January 31, 1978
GQL 0147

Three Mile Island Nuclear Station Unit 1 (TMI-1)
Operating License No. DPR-50
Docket No. 50-289
Cask Drop Analysis Additional Information

In response to your letter of August 18, 1977, and per our letter of November 22, 1977 (GQL 1622), enclosed please find the subject additional information.

FIGURE 1-3

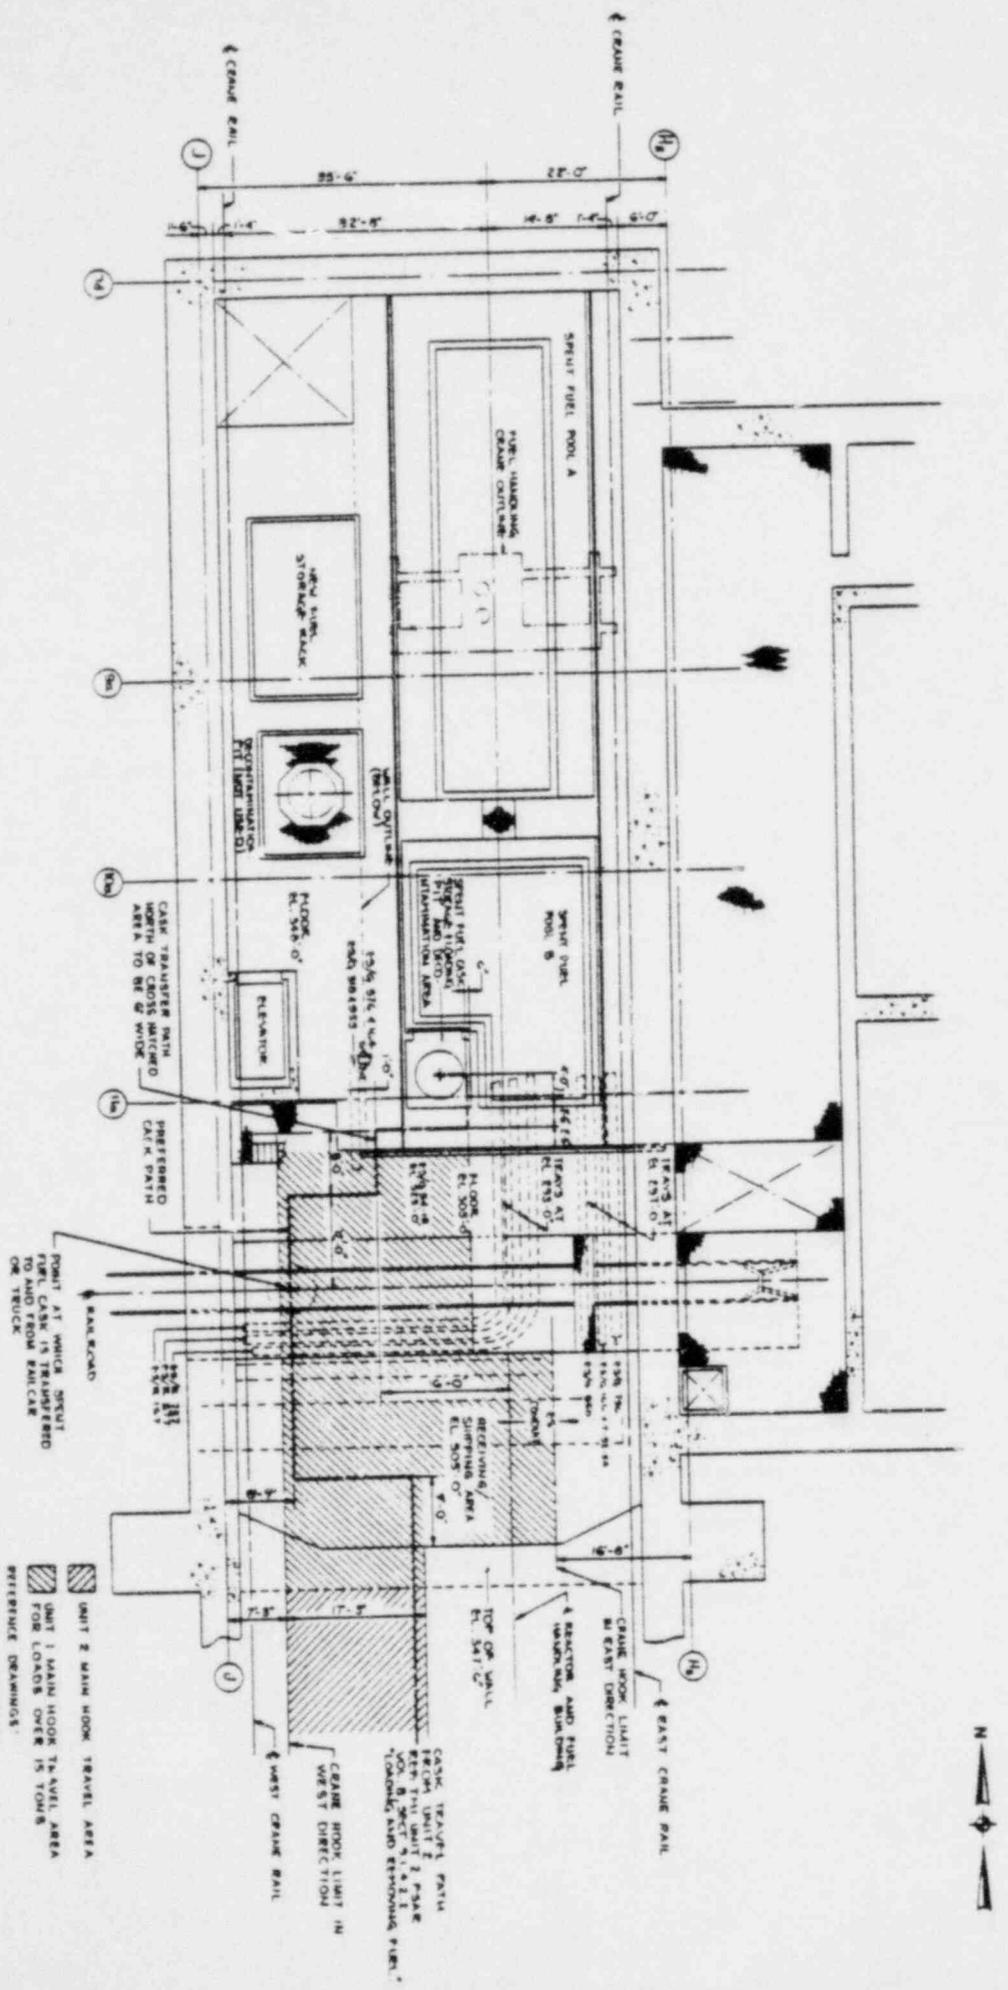
submittal. Further, FSAR Figure 1-3 shows that the Unit 1 temporary new fuel storage area is located parallel to the transporter railroad tracks and could be in the path of the spent fuel cask as it travels to and from the Unit 1 decontamination area as well as the corresponding work stations in Unit 2.

Figure 1-3 TMI-1 FSAR

- (1) "Temporary New Fuel Storage Rack" changed to "Receiving/Shipping Area."
- (2) "Spent Fuel Cask Storage Area" changed to "Spent Fuel Cask Storage & Loading Pit and Decontamination Area."

PLAN-FUEL HANDLING BUILDING
 ELEV. 348'-0" AND 305'-0"
 FIGURE 1

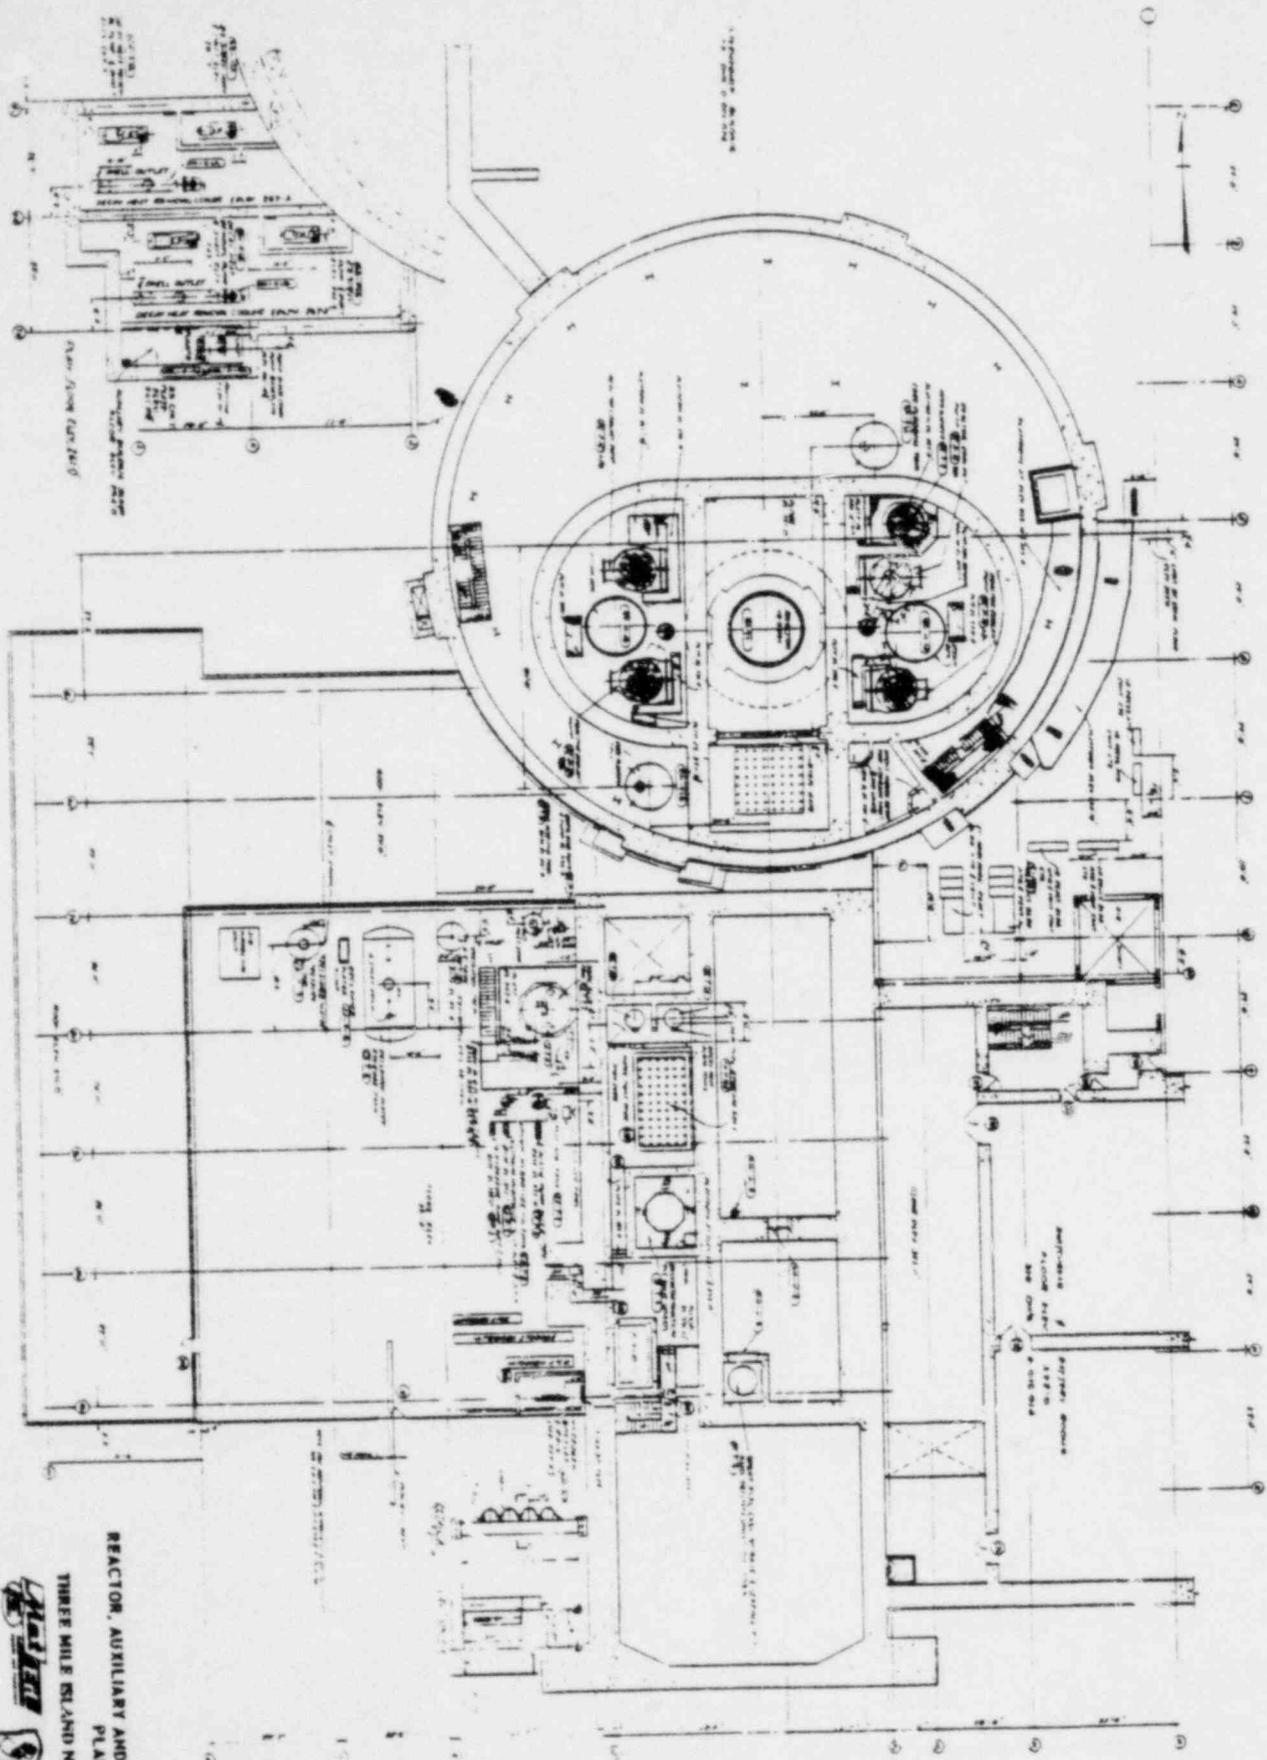
- 1.1 Provide one drawing showing the relative location of the following areas of Unit 1: (i) the new fuel storage areas; (ii) the spent fuel storage pool; (iii) the spent fuel cask storage and loading pit; and (iv) the specific location of the cask decontamination area.

1.2 To adequately evaluate the potential for unsafe conditions occurring in Unit 1 following a cask drop accident at any point along its revised path of travel between the transporter, the newly located decontamination area, and the spent fuel cask loading pit, superimpose the travel paths of the shipping cask for Unit 1 and 2 within the Unit 1 building on the drawing requested above.

1.3 Verify that the path of travel of the spent fuel cask from the transporter to the Unit 2 building has not changed due to these proposed changes or describe, discuss and demonstrate that no safety related consequences could result from these changes.

2.2 Demonstrate that following a cask drop accident the cask will not tip, roll, or impact on Unit 1 temporarily stored new fuel in a manner which would lead to a criticality accident. In particular, state a maximum

The requested information is shown on Figure 1.

The travel path of the shipping cask for Unit 1 and 2 within the Unit 1 building is shown on Figure 1.

The path of travel of the spent fuel cask from the transporter to the Unit 2 building remains as shown in the TMI-2 FSAR, Volume 8, Section 9.1.4.2.2. See Figure 1.

As shown on Figure 1, the area south of the railroad track is no longer designated as a temporary storage area for new fuel. New fuel will be receipt inspected in this area and then will be transferred to the new fuel storage racks shown in Figure 1 or to the spent fuel pools. No new fuel will be permitted in the receiving/shipping area during cask handling operations. Therefore the questioned impact of an accident on Unit 1 temporarily stored new fuel cannot occur.

FSAR Figure 9-18A will be revised showing the new key interlock limits of travel of the crane. This will be accomplished by substituting Figure 1 for 9-18A. Additional details are also shown in Figures IV-4 and IV-6 of the February 14, 1976, submittal.

FIGURE 2-A

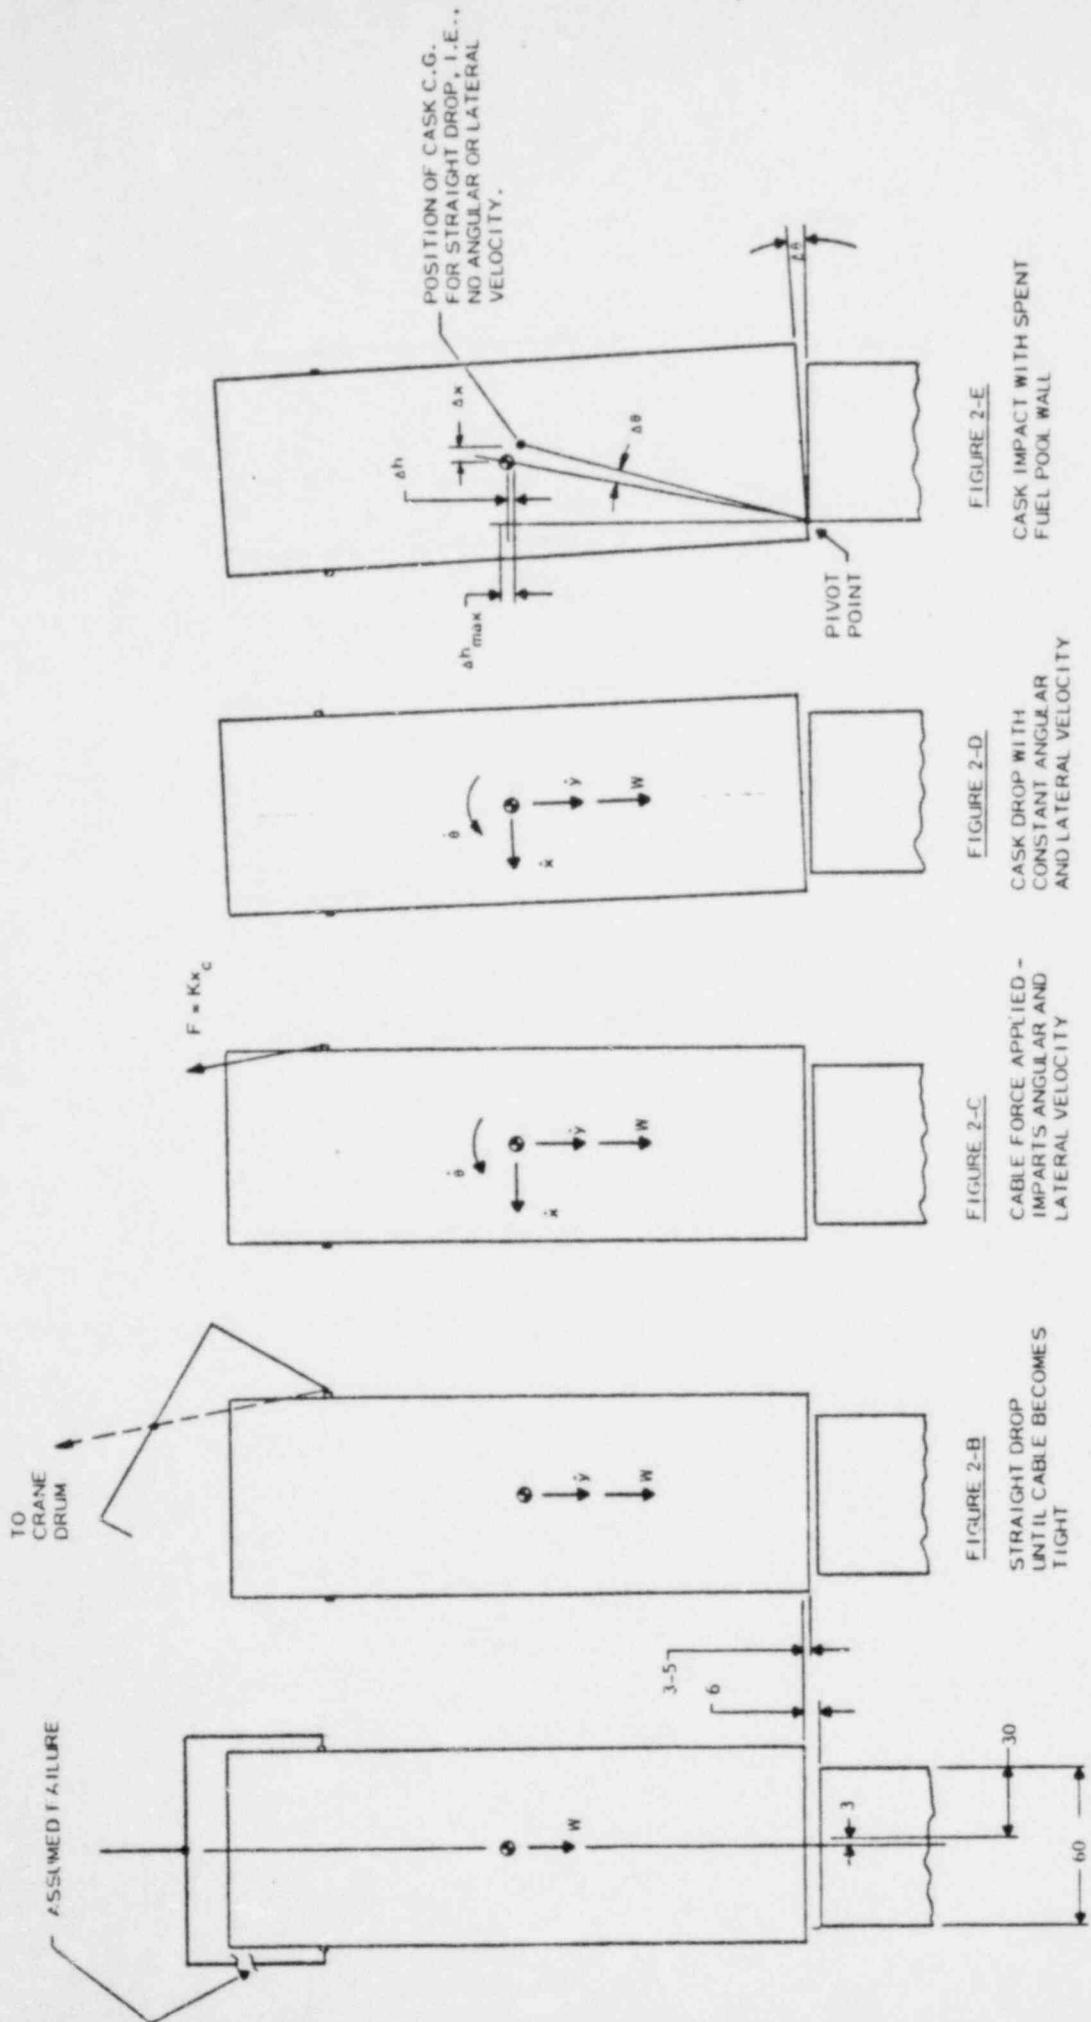
12.0 Provide a summary of the cask stability analysis when the cask is dropped on the south wall of the "B" spent fuel pool for both eccentric and straight drop conditions."

Results of the cask stability analysis when the cask is dropped onto the 5-foot wide south wall of the "B" spent fuel pool are presented below for the eccentric drop condition. Results for the straight drop are less severe than the eccentric drop condition and therefore are not controlling.

1. The cask bottom surface is assumed to be raised 6 inches above the top of the spent fuel pool wall and the cask center of gravity is assumed to be located 3 inches from the center of the 6-inch wide transfer path as shown in Figure 2a.
2. The lifting trunnion or lifting yoke arm on one side of the cask is assumed to fail. This lets the cask drop straight down 3 to 5 inches (depending on the cask involved, until the resulting slack in the system is removed, i.e.,

a straight line of action is established between the unfailed cask trunnion, the center of the lifting yoke and the cable drum as shown in Figure 2b. At this point, the cable becomes tight.

3. As the cask continues to drop the load in the cable increases in direct proportion to the stretch of the cable. The eccentrically applied load reduces the cask's vertical velocity and imparts angular and lateral velocity to the cask as shown in Figure 2c.

4. Eccentric drop analyses indicate that the maximum force produced in the cable is about 4 times the weight of the cask. At this load, the up until now unfailed cask trunnion or yoke arm is expected to fail. The cask then free falls with constant angular and lateral velocity as shown in Figure 2d until it impacts the top of the south wall of the "B" spent fuel pool.

5. The angular and lateral kinetic energy of the cask at impact are determined from the above model. Assuming all of this energy goes into increasing the potential energy of the cask, the amount the cask center of gravity is raised due to tipping is calculated as shown in Figure 2e. The cask is considered stable and will not tip over if the cask center of gravity is on the stable side of the pivot point, i.e., to the right of the pivot point shown in Figure 5.
